City Planning Commission  
Sacramento, California

Subject: Variance Time Extension (P87-075)

LOCATION: 1215 G Street

## SITE PLAN

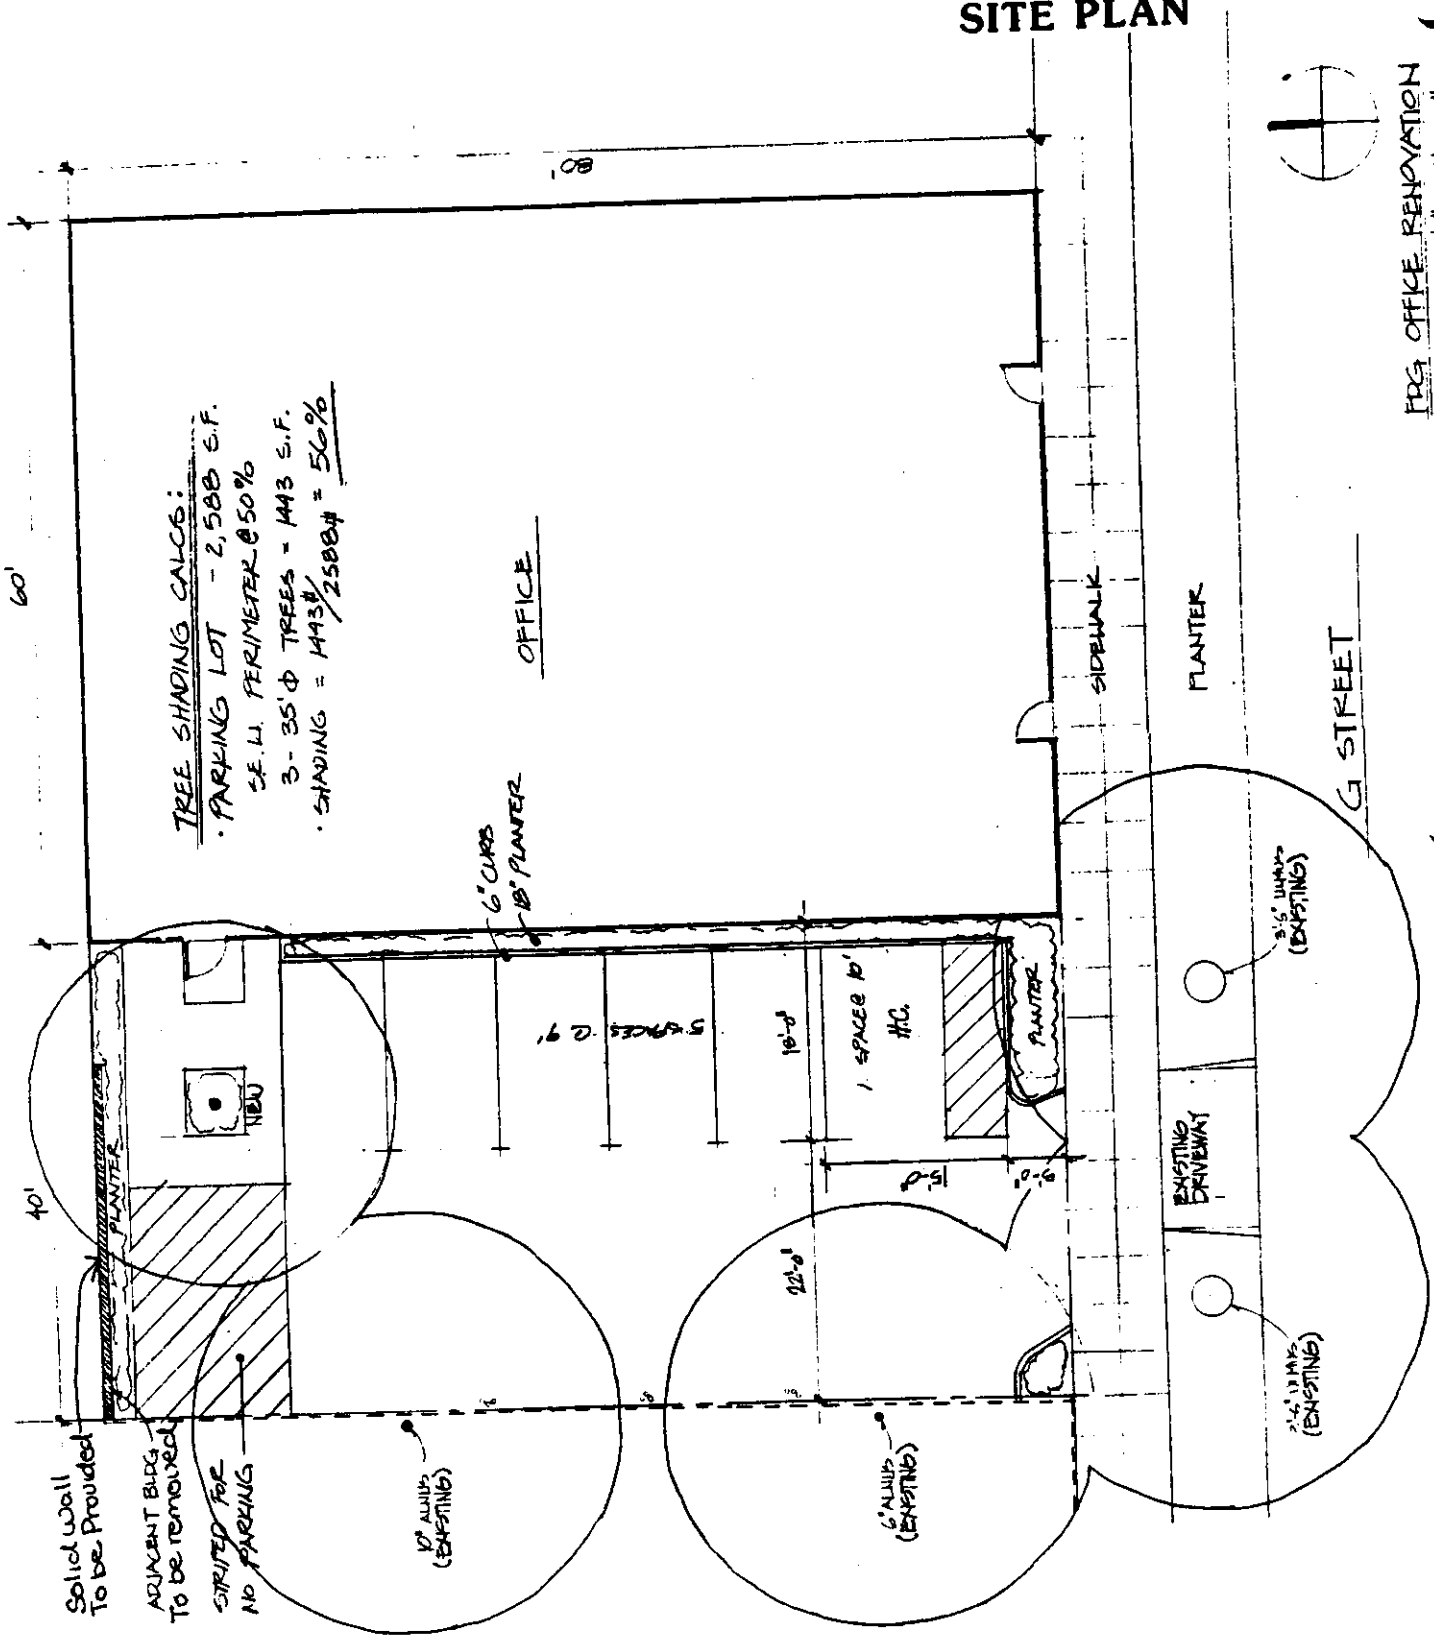
The proposed parking lot site is only 40 feet wide and a variance is requested to reduce the required maneuvering width to 22 feet. At staff suggestion the applicant has designed the parking spaces to be 9-feet wide to compensate for the lack of maneuvering depth. Planning and Building Division staff find that this site plan modification will compensate for the reduction in maneuvering area.

The applicant is also requesting a variance to reduce the 50 percent shading requirement. A new tree will be planted on the site which will produce 34 percent shading for the site. A second tree could be planted in the southern planter on the site which would achieve the 50 percent shading requirement. A tree planted in this area, however, would grow misshapen and probably die due to the fact it would be planted under the existing elms. Planting a new tree in this area may also be harmful to the root system of the existing elms. The shade produced by existing off-site trees and the proposed new tree will exceed the 50 percent shading required for the site. Staff, therefore, does not object to the variance request to reduce the shading requirement to 34 percent.

The project has been reviewed by the City Traffic Engineering Division. As noted above, a variance will be required to utilize an existing driveway of substandard width. Traffic Engineering recommends that the planter at the southwest corner of the site be extended to a length of approximately 12 feet from the western property line and if either of the City's elm trees are removed in the future that the driveway be redesigned to meet the requirements of the Traffic Engineering Division.

1. Revised landscape, shading and irrigation plans shall be submitted for staff review and approval prior to issuance of building permits. Screening shrubs shall be planted in the southern planter and the planting area for the tree on the northern portion of the site shall be wide enough to meet the 34 percent shading requirement.
2. The applicant shall obtain a variance from the City Council to use the existing driveway for the proposed parking lot.
3. The design and materials of the required six-foot high solid wall along the north property line shall be subject to Planning Director review and approval prior to issuance of building permits.
4. The applicant shall enter into an agreement with the City indicating that the parking lot on the western lot provides the required parking for the office

5. The project is subject to the review and approval of City Design Review/ Preservation Board staff.
6. If either of the City's two elm trees are removed, the site plan shall be redesigned to meet the driveway requirements of the City Traffic Engineering Division and an additional tree for shading purposes shall be planted on the subject site.
